ITS3 activities in Bari

BBM6 Thermal Test Assembly

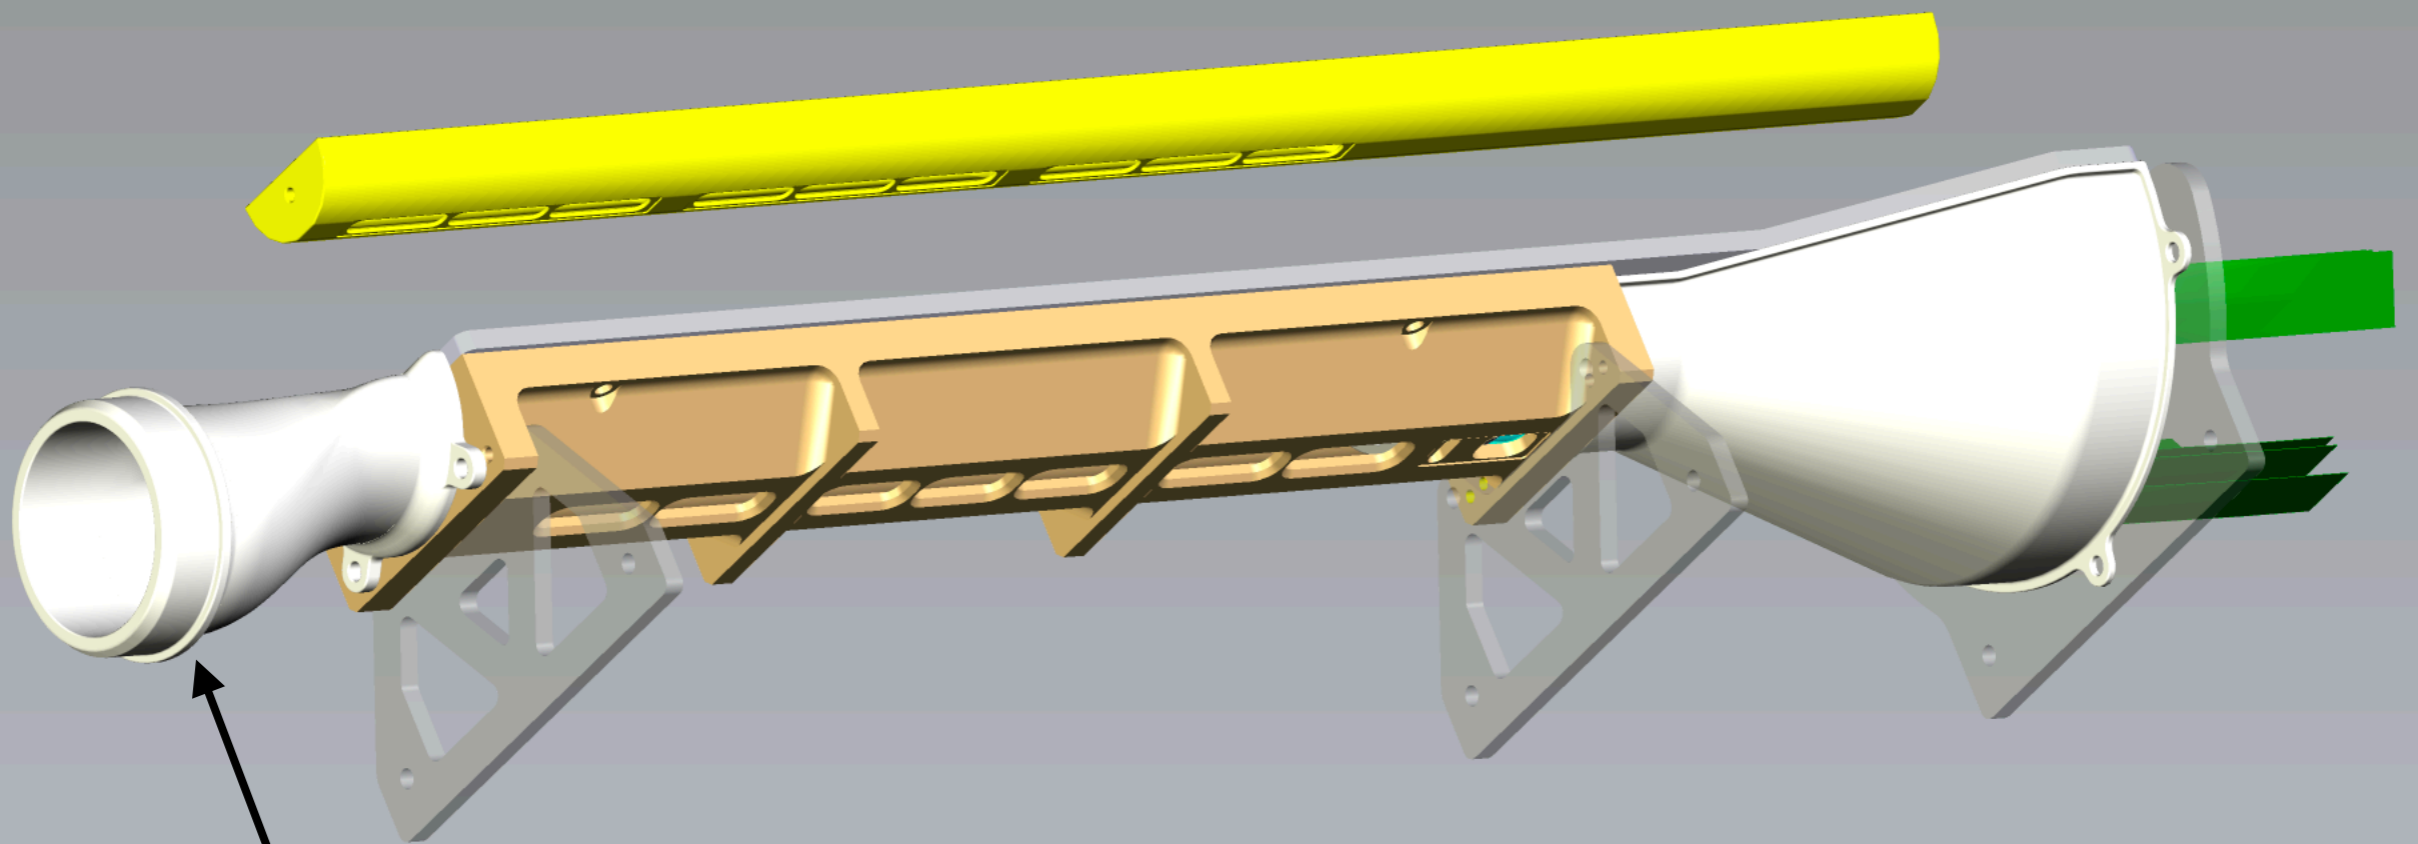
Are these supports used?
The holes in the bottom part of the supports have a special meaning and should be kept?

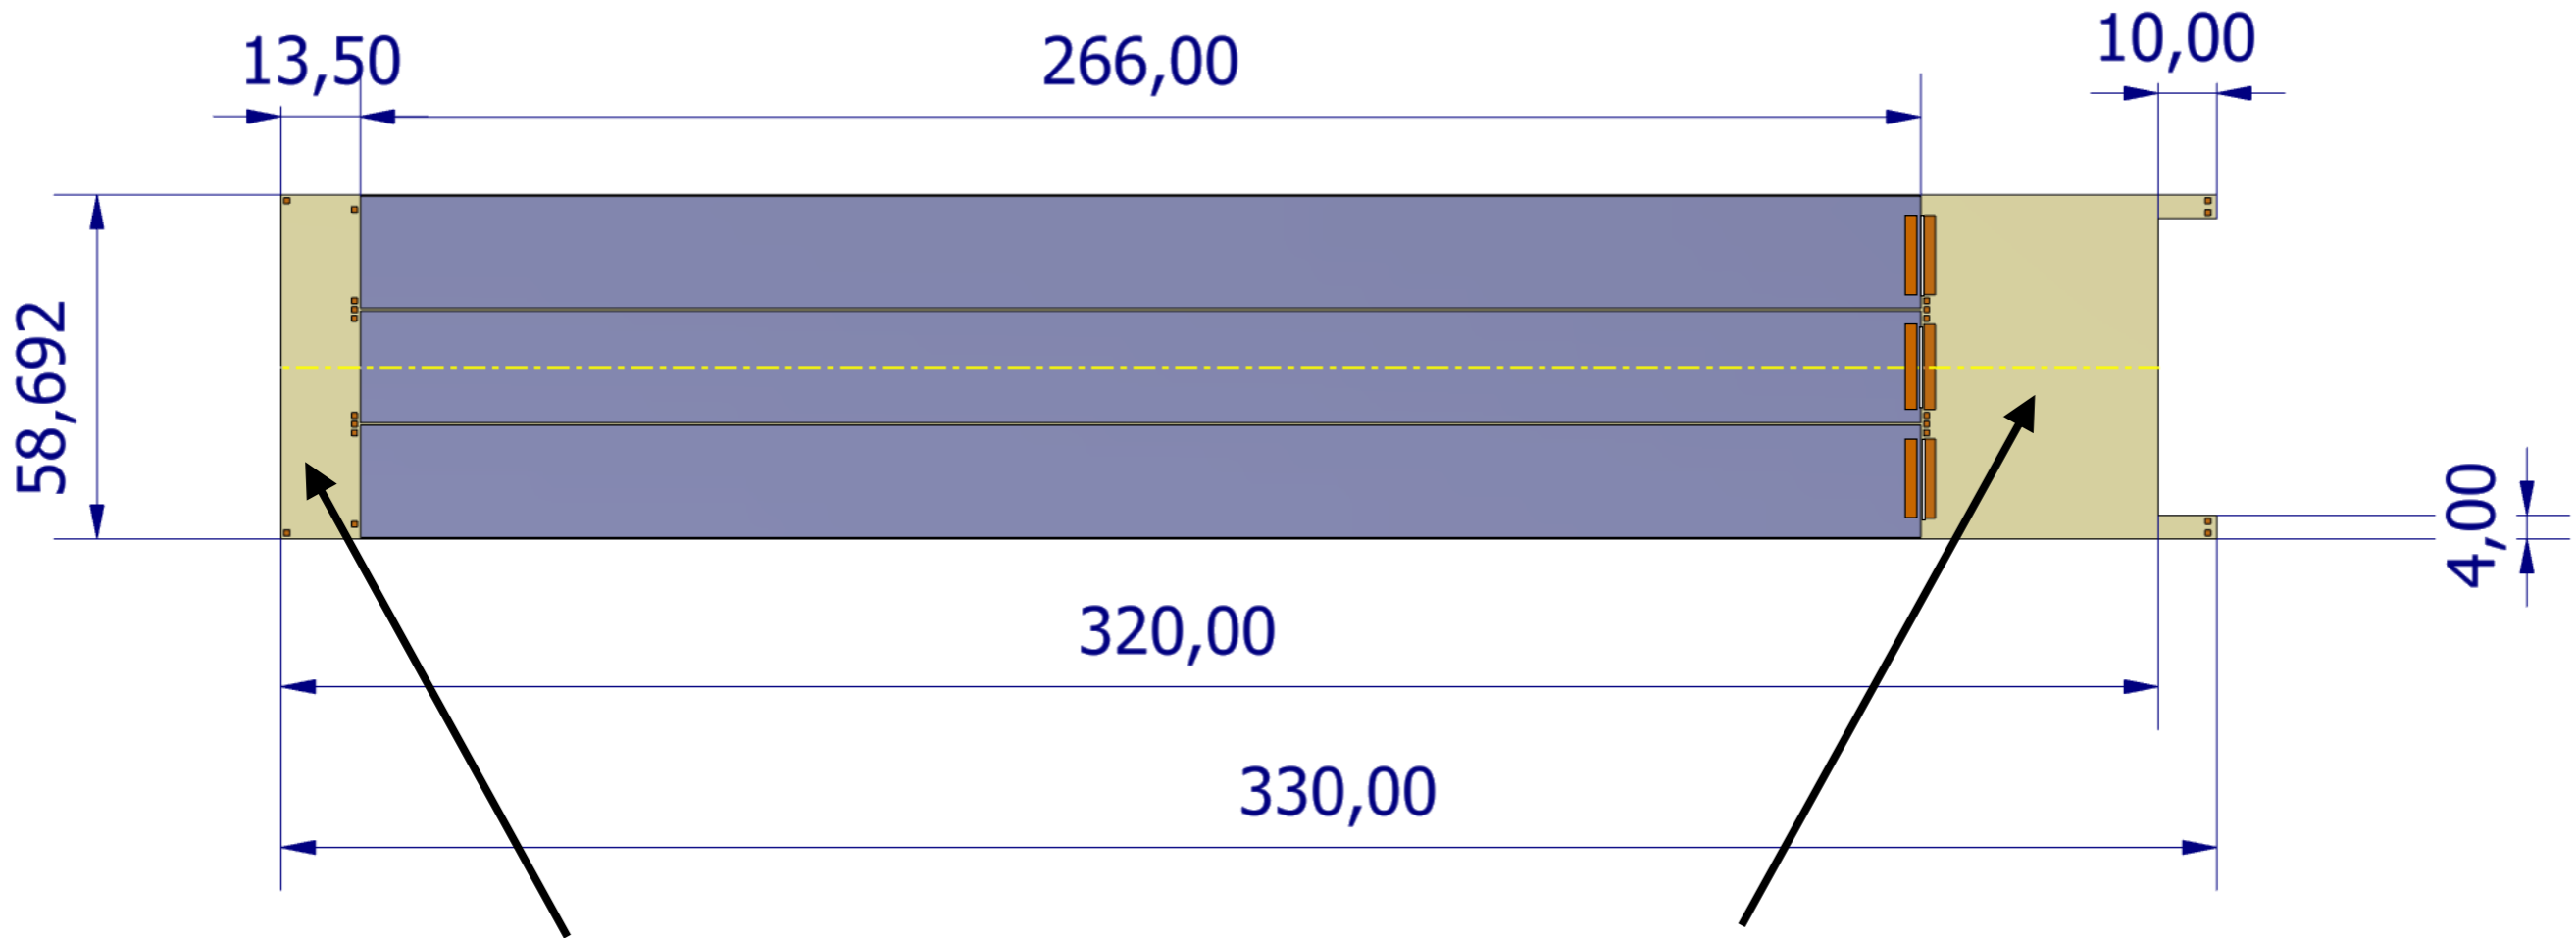
This needs to be redesigned.
Should we do it or you prefer to implement special constrains?
I assume that the diameter of the output should be kept.

Maybe question to Rui/Serge.
